UNITED STATES PATENT AND TRADEMARK OFFICE

APPLICATION NO.	FILING DATE	FIRST NAMED INVENTOR	ATTORNEY DOCKET NO.	CONFIRMATION NO.
09/909,229	07/19/2001	James Leo Czekaj	10541/421 V200-0758	9724

Office Action Summary

For SYSTEM & METHOD FOR TRANSMISSION OF DIGITAL
INFORMATION OF VARYING SAMPLE RATES OVER A
SYNCHRONOUS NETWORK
Inventor: James Leo Czcekaj et al Atty. Docket: 10541/421 V200-758

FIG. 3

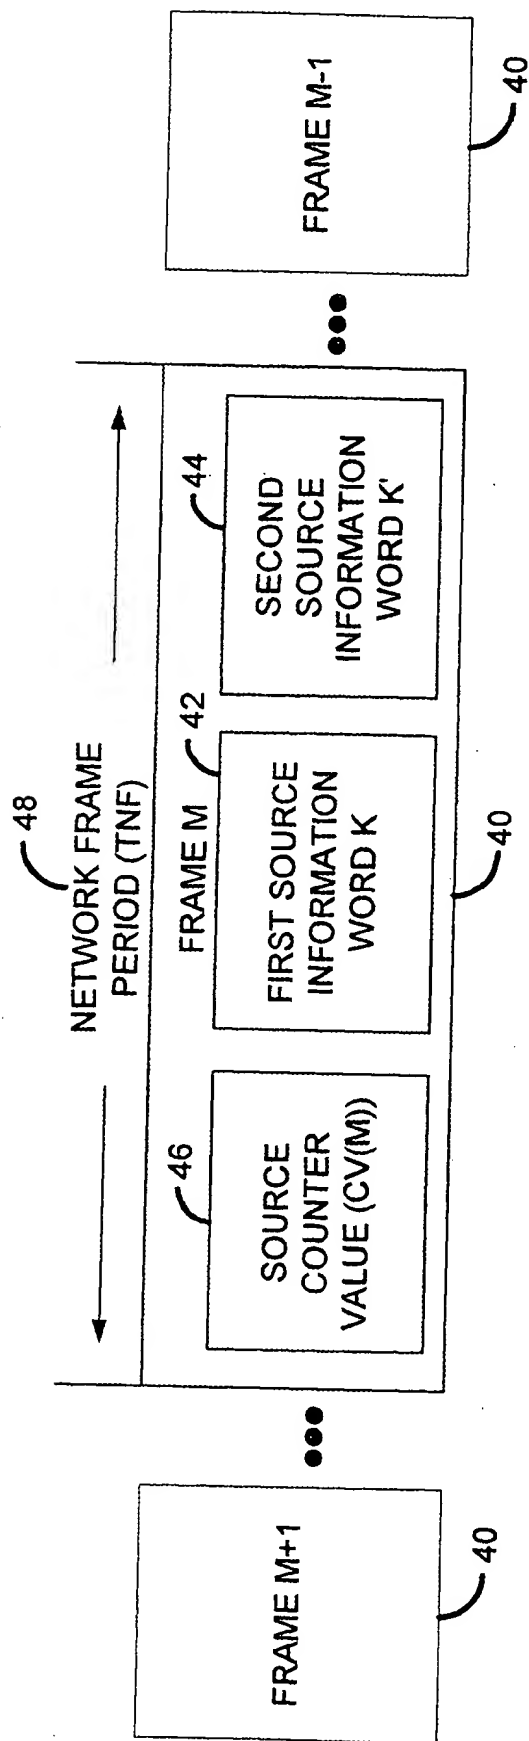
Page 16, 13-15). Furthermore, the specification also discloses multiple sources and sinks operating at various sample rates (Specification, Page 2, lines 18-24). Furthermore, Fig. 3 discloses a plurality of network frames wherein the figure describes a network frame in further detail (Fig. 3, element 48), comprising a source counter value (Fig. 3, element 46), a first source information (Fig. 3, element 42) and a second source information (Fig. 3, element 44), however, the specification does not describe, in such a way as to enable one skilled in the art to which it pertains, or with which it is most nearly connected, to make and/or use the invention, that if each source (first and second) as described in the figure are operating at different sample rates from one another, then it is not clear which source (sample rate) the counter value would represent, since the figure shows one counter value in the frame representing data from multiple sources.
